PROPOSED SOCIAL WELFARE FACILITY (RESIDENTIAL CARE HOME FOR PERSONS WITH DISABILITIES) IN "VILLAGE TYPE DEVELOPMENT" ZONE ON APPROVED NAM SANG WAI OUTLINE ZONING PLAN NO. S/YL-NSW/10 AT LOTS 3669 S.A RP (PART), 3669 S.B RP (PART), 3670 RP (PART) AND ADJOINING GOVERNMENT LAND IN D.D.104, NAM SANG WAI, YUEN LONG

Town Planning Application No. A/YL-NSW/348 - Submission of Further Information (3)

**(Planning Application No. A/YL-NSW/348)
Response-to-Comment Table**

FIGURE 2
EXISTING SEWERAGE SYSTEM

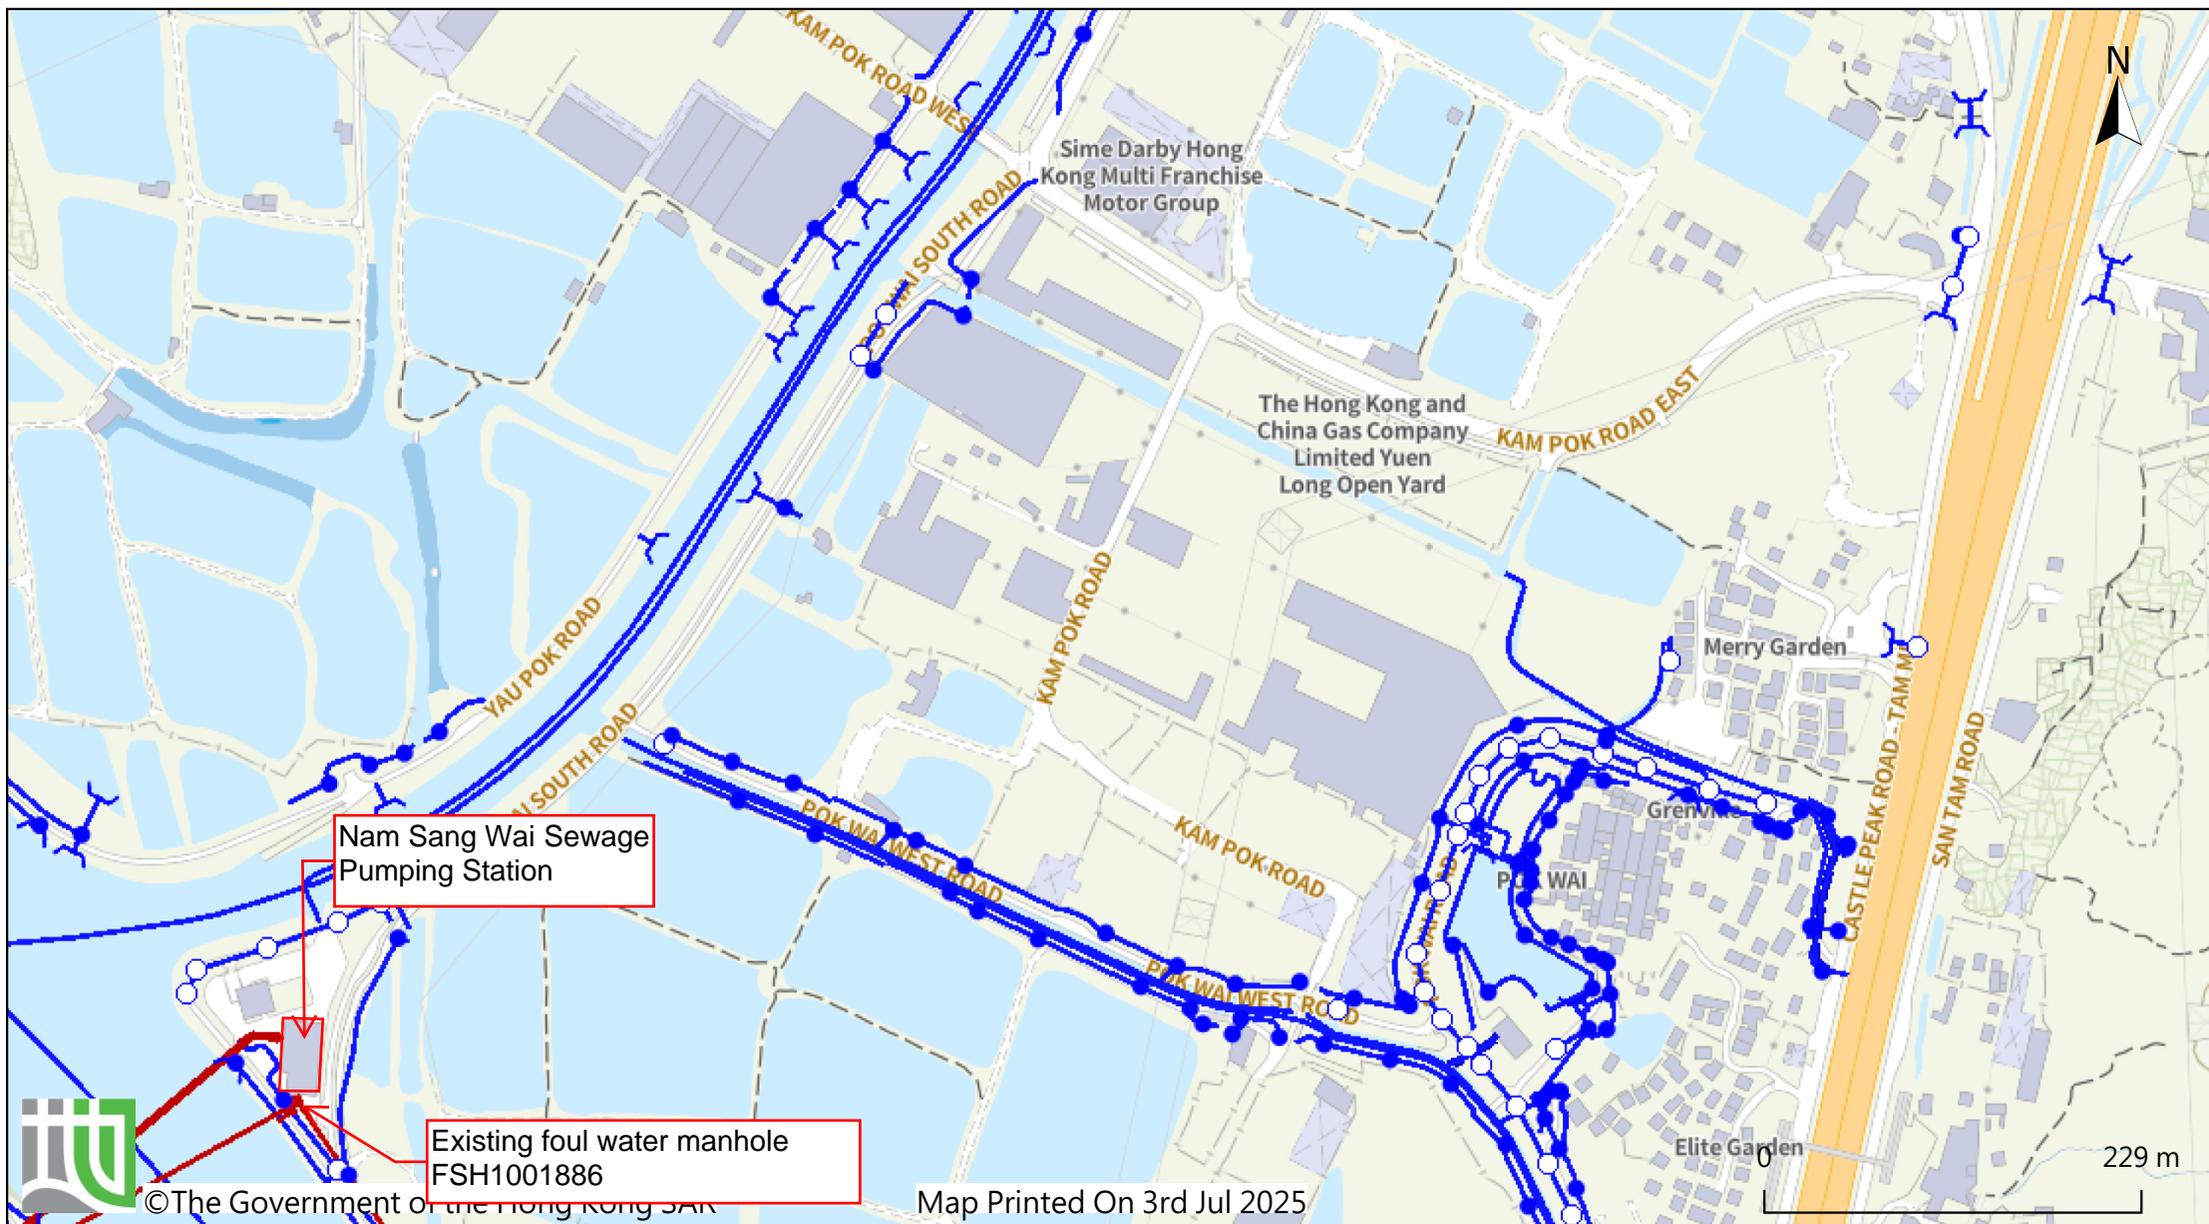
1. RtC item 1, Section 2.2.2, Figures 2 & 3 – As shown in Figure 2, there is no existing public sewerage along Kam Pok Road East and Pok Wai South Road. Please clarify and provide information to support the existence of sewer mentioned under S.2.2.2. Please supplement with information of the upgrading works under A/YL-NSW/314 proposed to be utilised for discharging sewage from the application site. Please also clarify the party responsible for the construction of the sewers along Kam Pok Road East and Pok Wai South Road etc. proposed to serve the application site for sewage disposal as shown under Figure 3.

FIGURE 3
PROPOSED TERMINAL MANHOLE AND
CONNECTION

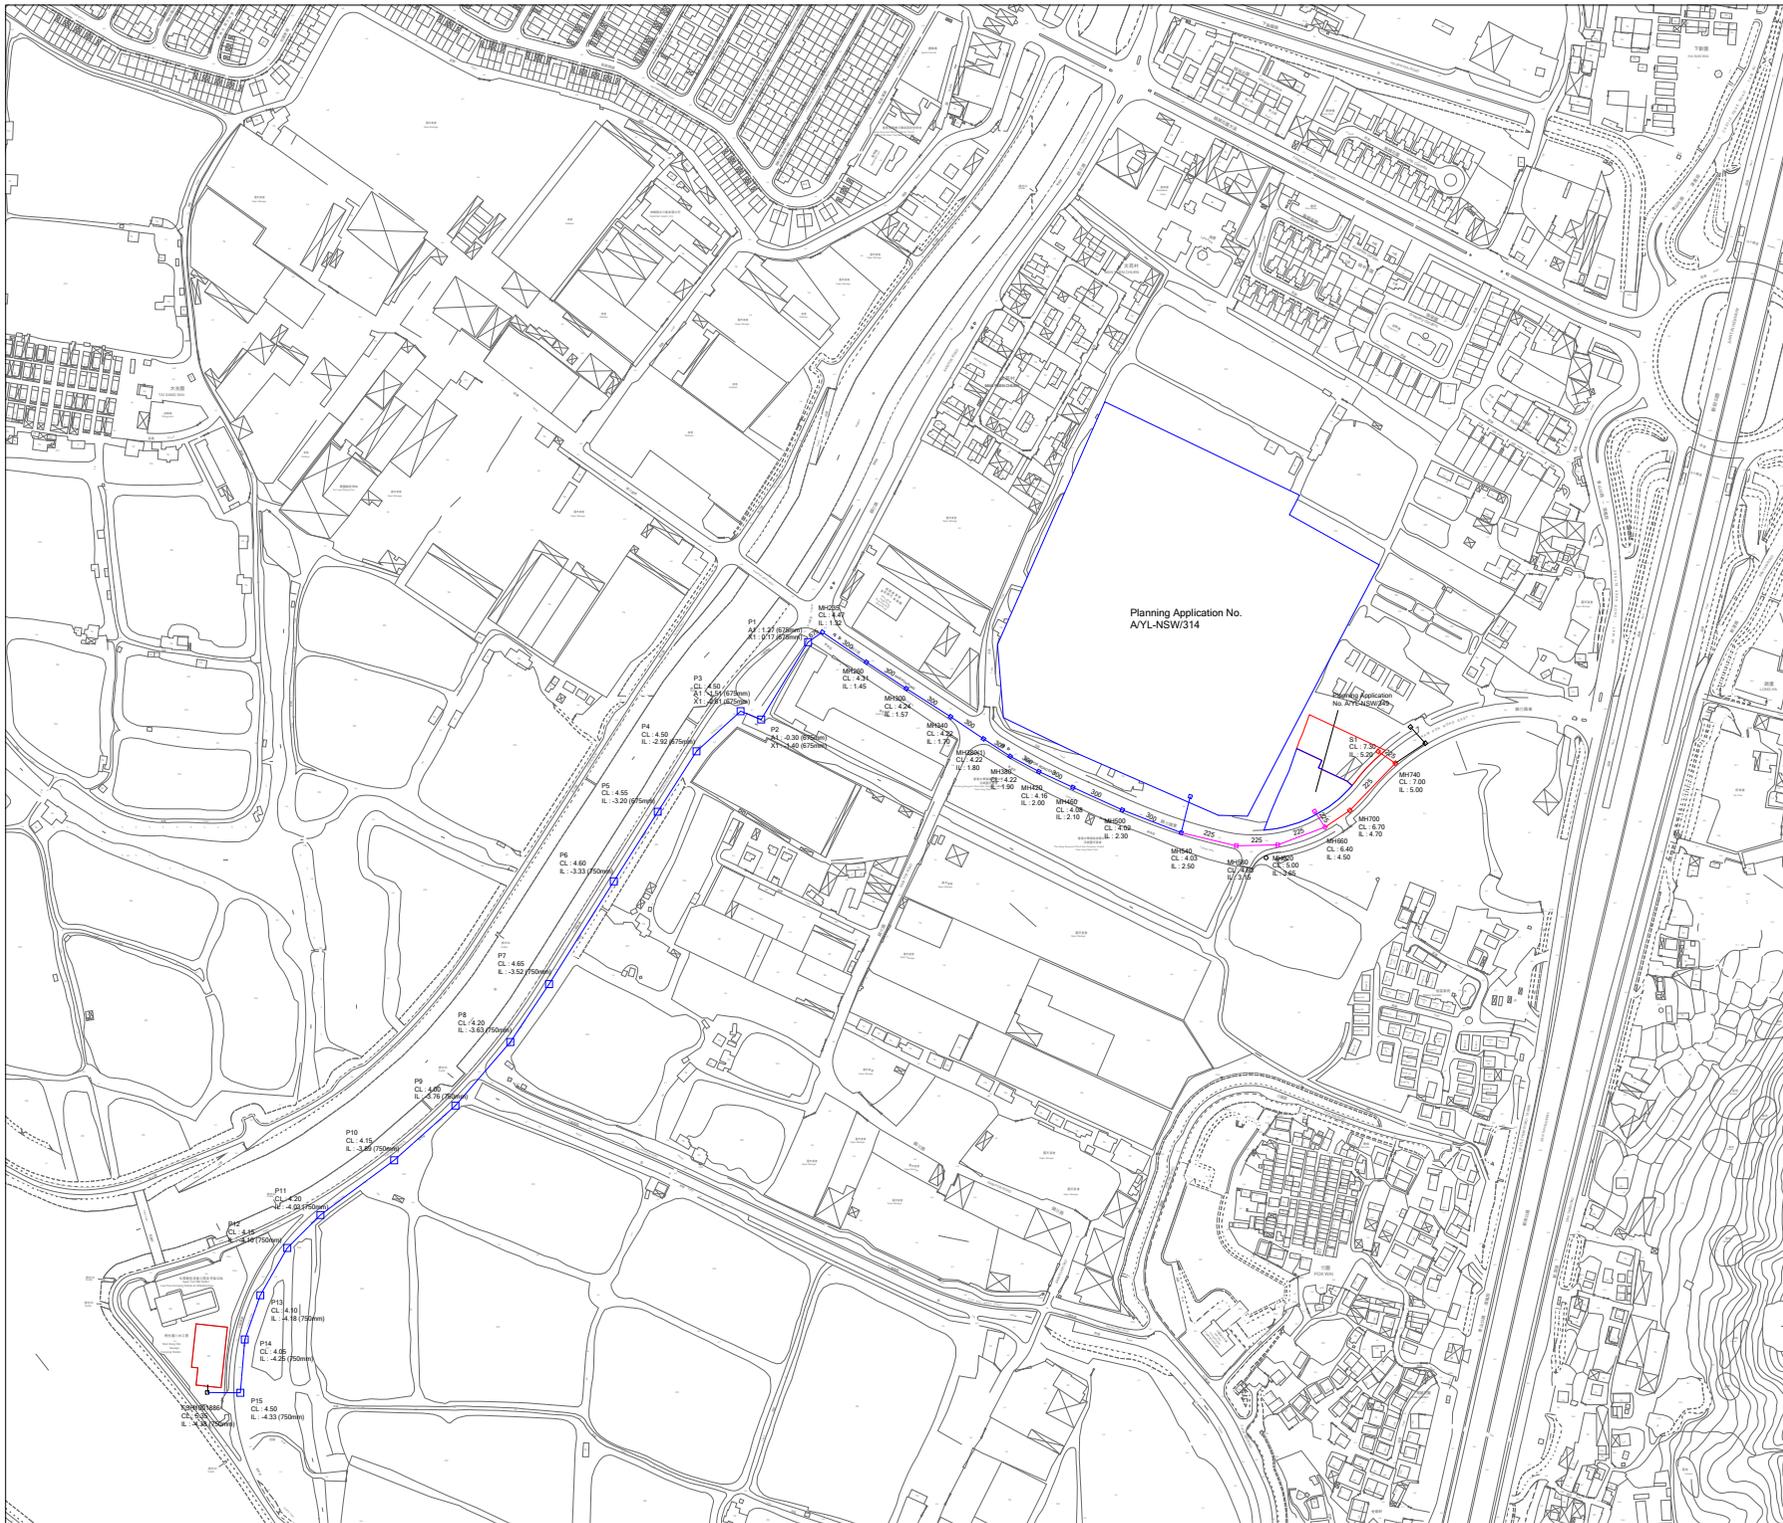
4. Figure 3: Information of existing sewerage system shown on the submitted sewerage plan is different from our sewerage record. The applicant should clarify discrepancies and advise whether modification of existing sewerage system is required and would be implemented by the applicant for the proposed development. Also, the applicant should clarify management and maintenance responsibilities of the proposed sewerage system after modification work (if any).	More information of existing sewerage system and proposed sewerage system including management and maintenance responsibilities are provided in Section 2.2 to 2.5.

5. Section 3.1.2 & Figure 3: The applicant should clarify whether 300 mm dia. sewers are existing sewers or newly proposed sewers. Also, the applicant should clarify words, i.e. '...existing sewerage system...'	300 mm dia. sewers are proposed by approved planning application A/YL-NSW/314.

6. Figure 3: For Catchment A, the applicant should provide information regarding the proposed development at private lots (Lot No.: 3670 RP, 3671 RP, 3672 RP and 3673 RP in D.D. I 04). The applicant should also clarify whether Catchment B is referring to another planning application (No.: ANL-NSW/314). Besides, please clarify the mitigation measures if the sewerage works proposed under other planning applications, such as A/YL-NSW/314, Y/YL-MP/10 and etc., could not match with the programme of the proposed development.	Figure 3 is revised accordingly. For situation if the sewerage works proposed under other planning applications, such as A/YL-NSW/314, Y/YL-MP/10 and etc., could not match with the programme, there will be no population intake for the proposed development until proposed sewerage system becomes available. Relevant explanation is provided in Section 2.4.

7. Figure 3: Please clarify the '-' sign of cover levels and invert levels shown on the submitted drawing.	'-' sign refer to height below m.P.D. level.

8. Figure 3: The applicant should clarify invert levels of the proposed foul water manhole P3. Invert levels of the proposed sewerage facilities at the upstream shall be higher than that at the downstream.	The invert level is revised.

9. Figure 3: The ID nos of the existing government manholes to which sewerage connection is made should be indicated on the submitted sewerage plan.	Noted.

10. Figure 3: The applicant should clarify cover levels of the proposed manholes PI-P15. Also, the applicant should clarify whether manhole EI shown on the submitted sewerage plan is existing foul water manhole FSH1001886. The applicant should indicate cover level and invert levels of existing foul water manhole FSI-11001886 on the submitted sewerage plan for reference.	Cover levels are provided. Manhole E1 is revided to manhole FSH1001886.

<p>11. Figure 3 & Appendix B: The applicant should clarify discrepancy of size of sewer connecting the proposed manholes MH235 and P1. Also, the applicant should clarify invert level of the proposed sewer connecting to manhole E1.</p>	<p>Size of sewer and invert level is revised and corrected.</p>
<p>12. Appendix B': Design flow velocity is suggested to be within a range, i.e. 0.7 m/s to 3.0 in/s. The applicant should review hydraulic calculation for the sewers connecting the proposed manholes MH235 and P3.</p>	<p>Flow velocity is reviewed and all within 0.7 m/s to 3.0 m/s.</p>
<p>13. According to the submitted SIA, the applicant would like to connect the proposed sewerage system of the subject application site to existing sewerage system which has not yet been commissioned and the proposed sewerage system under other planning applications (No.: A/YL-NSW/314 and etc.). Satisfaction of the submission and implementation of SIA under the subject planning application is subject to acceptance and satisfactory implementation of SIA under other planning applications (No.: A/YL-NSW/314 and etc.).</p>	<p>Noted, further liaison with EPD/DSD and the other future developments near the Proposed Site would be in later stage.</p>

<p>14. Figure 3: The applicant should note that there are several planning applications/proposed developments in the vicinity of the application site and the sewerage system proposed under the subject planning application may have conflict with that proposed under other planning applications (No.: Y/YL-NSW/7 and etc.). The applicant should liaise and coordinate with EPD and other project proponents to confirm the proposed sewerage design and ascertain responsibilities of implementation and maintenance of the proposed sewerage works.</p>	<p>Noted, further liaison with EPD/DSD and the other future developments near the Proposed Site would be in later stage.</p>
<p>15. The SIA needs to meet full satisfaction of Sewerage Infrastructure Group (SIG) of Environmental Protection Department (EPD), the planning authority of sewerage infrastructure. Since there are various proposed developments which are planned to dispose sewage to Nam Sang Wai Sewage Pumping Station (NSWSPS), advice from SIG of EPD should be sought for holistically review of the sewerage arrangement and confirming whether capacity has been reserved at NSWSPS for the subject proposed development. Comments of this department on the sewerage aspect are subject to the views and agreement of EPD.</p>	<p>Noted, further liaison with EPD/DSD and the other future developments near the Proposed Site would be in later stage.</p>

Figure Title **THE WALKING PATH BETWEEN THE PROPOSED RCHD AND THE NEARBY FRANCHISED BUS STOPS**

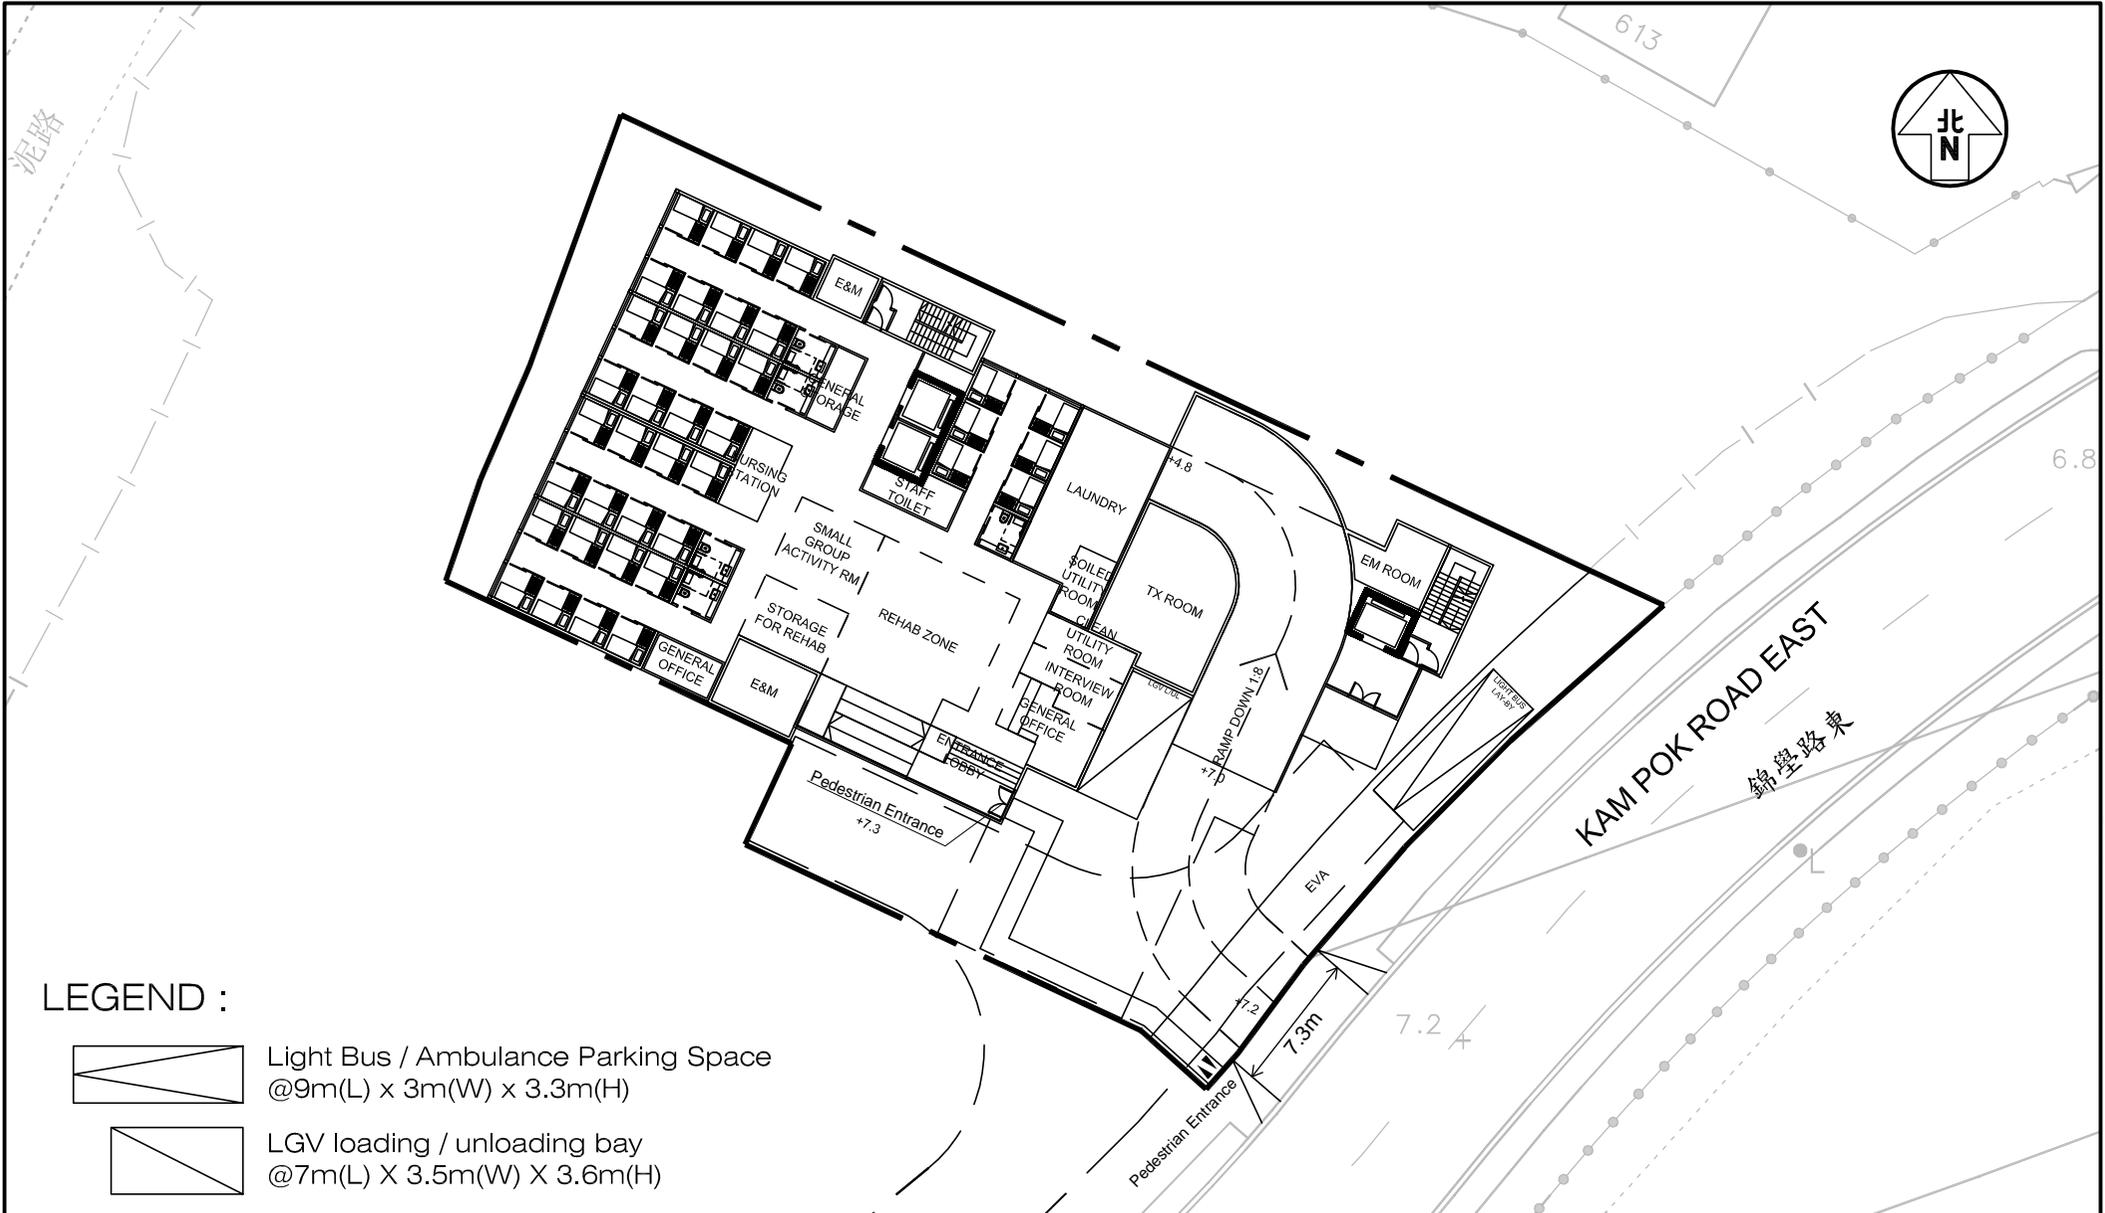
12. Please provide a plan showing the pedestrian routing to the nearby franchised bus stop (both Yuen Long and Sheung Shui bound). Please specify the corresponding walking distance as well;	Noted. Please refer to Figure 2.7 in the revised TIA for the pedestrian route to the nearby franchised bus stops.

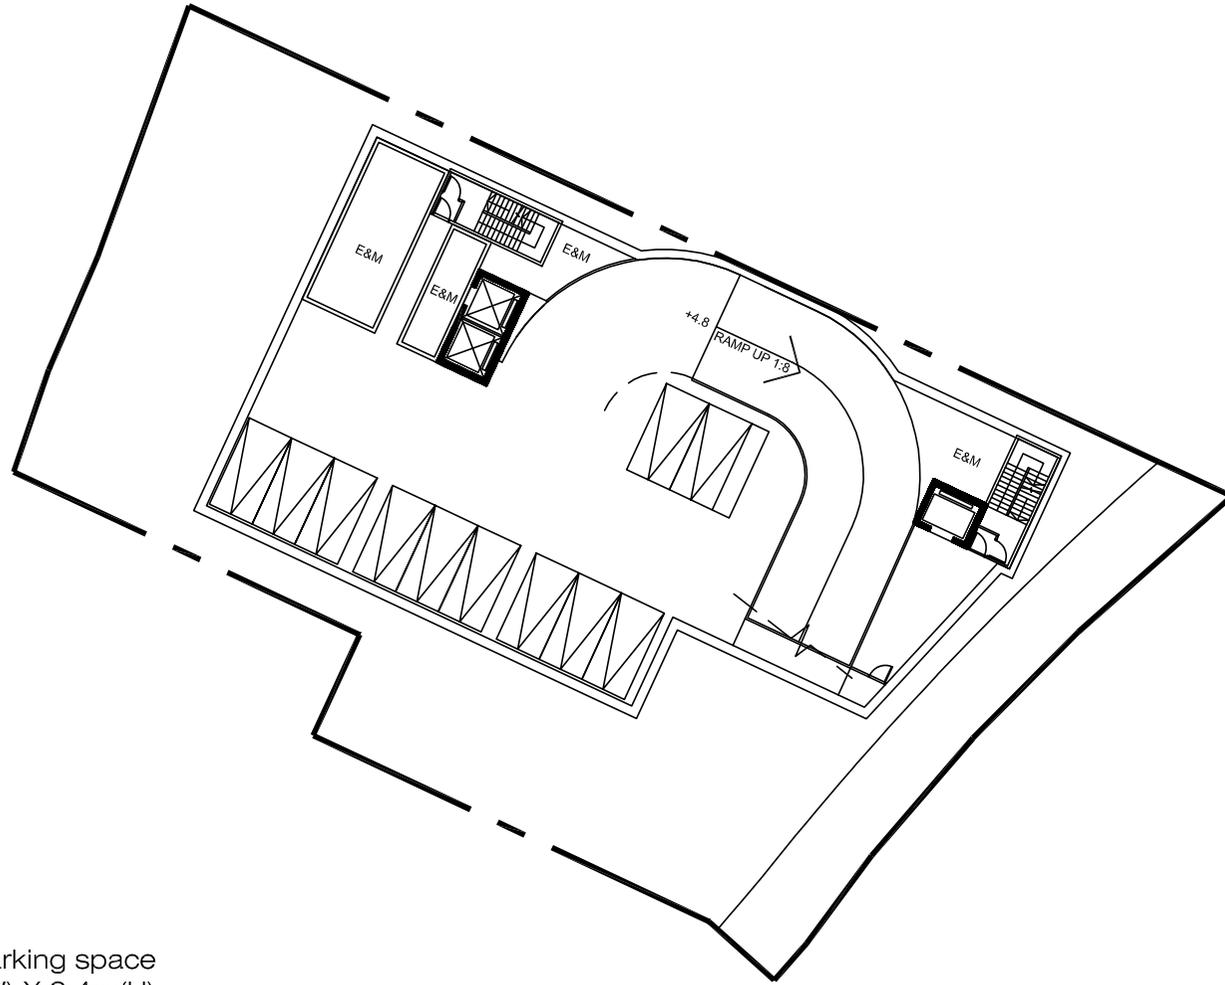
8. Please review the vehicle lift analysis based on the vehicle arrival rate in my comment (7).

12. Re. RtC item 11: In the site entrance, please provide a clear segregation between vehicles and pedestrians from road safety perspective. For the proposed pedestrian entrance in the building in Figure 3.1, apparently pedestrian is expected to walk across the vehicle manoeuvring area (i.e. car lift, light/ambulance, LGV, PCs/taxis) which poses a safety concern. Please review.

The carpark layout has been revised and a vehicle ramp is now provided from G/F to B/F car park. Please refer to **Figures 3.1 and 3.2** in the revised TIA.

Pedestrian entrance provided for the Proposed RCHD is separated from the manoeuvring area. Please refer to the **Figure 3.1** in the revised TIA.
